Docket No. 50-336
B11827

Millstone Nuclear Power Station, Unit No. 2
Reply to Request for Additional Information on Spent Fuel Storage Capacity

Millstone Nuclear Power Station, Unit No. 2
Response to Request for Additional Information on
Spent Fuel Storage Capacity

CESHOCK Model of Millstone 2 Region II
7 x 9 Spent Fuel Rack Module

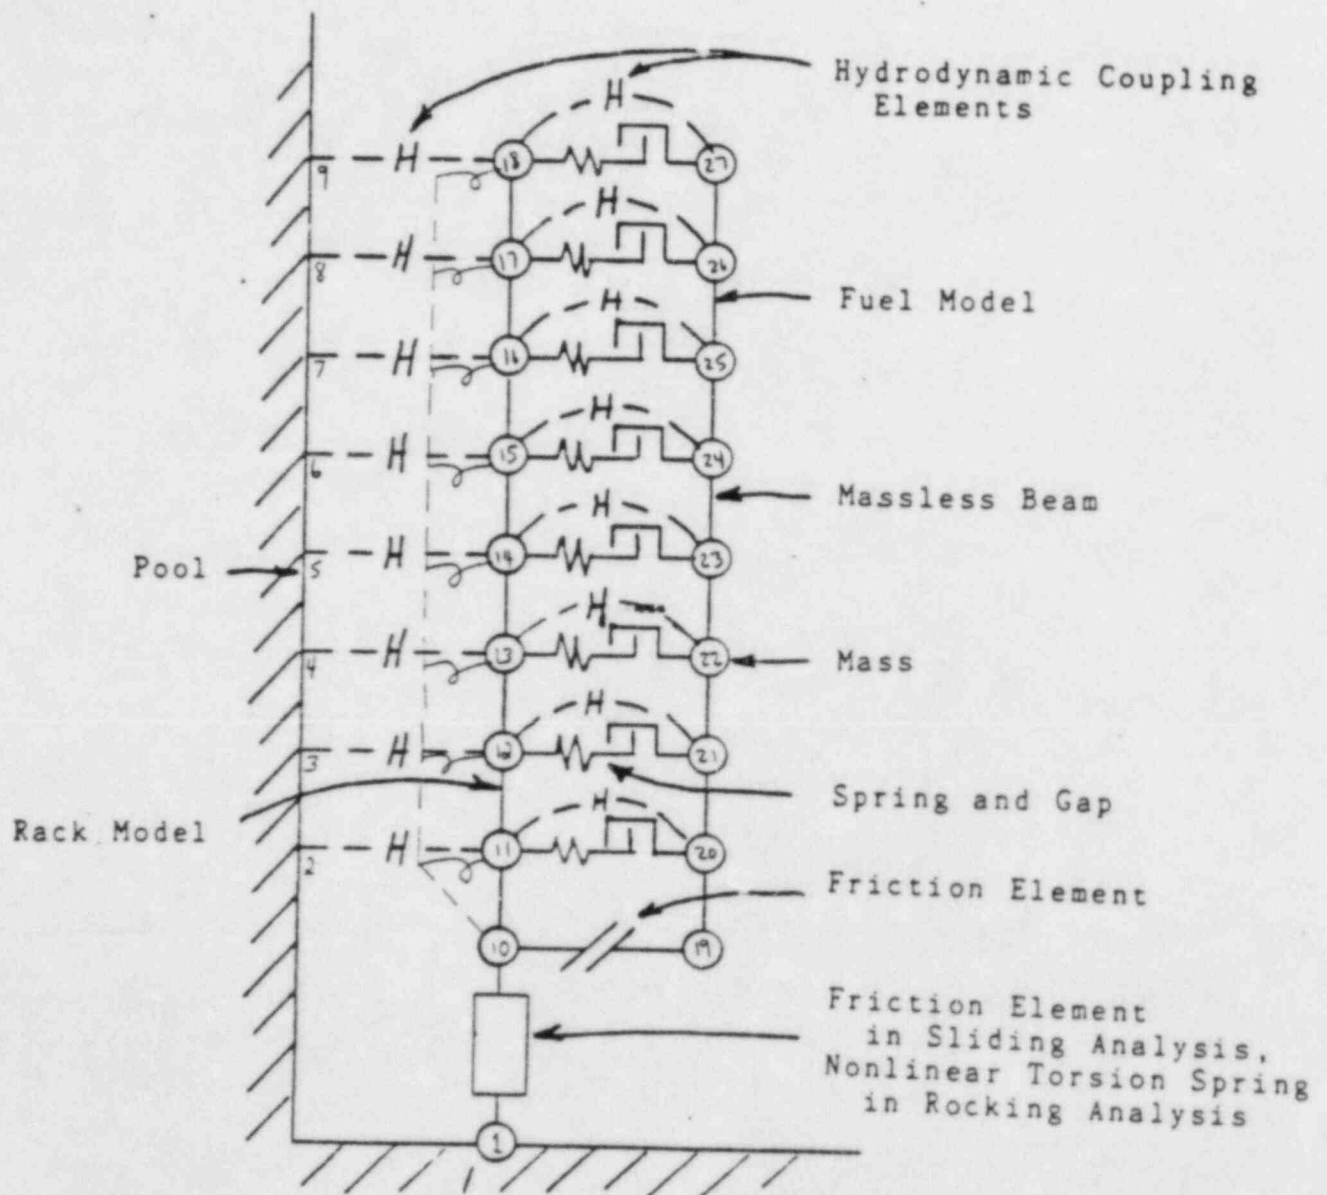
3. Provide a full description of the mathematical model used for the non-linear rack module analysis.

A schematic description of the mathematical model used for the non-linear rack module analysis is shown in Figure 1. The model is two-dimensional, with each mass having a translational and a rotational degree-of-freedom. Mass nodes 1 through 18 were used to represent the fuel rack module. These mass nodes were linked by massless flexible elements. Similarly, mass nodes 19 through 27 were used to represent the fuel. Hydrodynamic couplings, designated by element H, are included between the rack module nodes and the pool structure nodes, and between the fuel nodes and the rack module nodes. Nonlinear gap-spring elements were used to represent the possibility of impacting between the fuel and the rack module. The fuel was coupled to the base of the rack module by a "slip-stick" friction element. An element at the interface of the module base and the pool liner represented a "slip-stick" friction element in the sliding analysis and a nonlinear torsion spring in the shear and rocking analyses.

FIGURE 1
ISOMETRIC VIEWS AND KEY DIAGRAMS

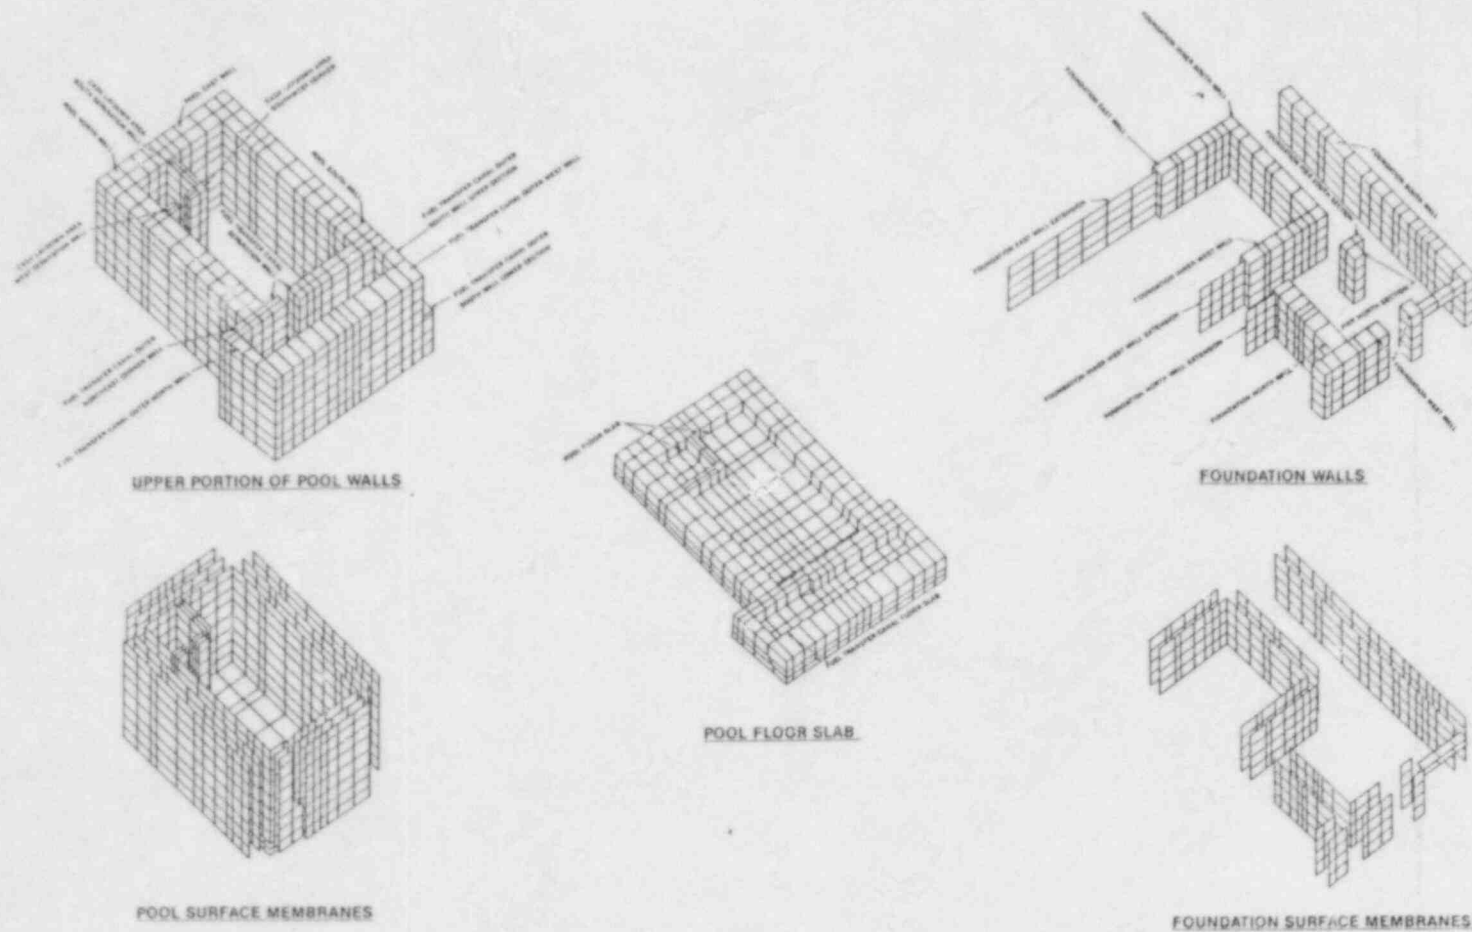
11.a. Provide sketches and drawings of the portions of the pool and auxiliary building structures to be modeled.

This section provides the finite element plots of the spent fuel pool, pool liner, and associated auxiliary building components covered by the analyses.

The spent fuel pool and associated auxiliary building components model contain over 9,600 degrees of freedom. Sketches are also provided of the floor liner plate model used in the analyses.
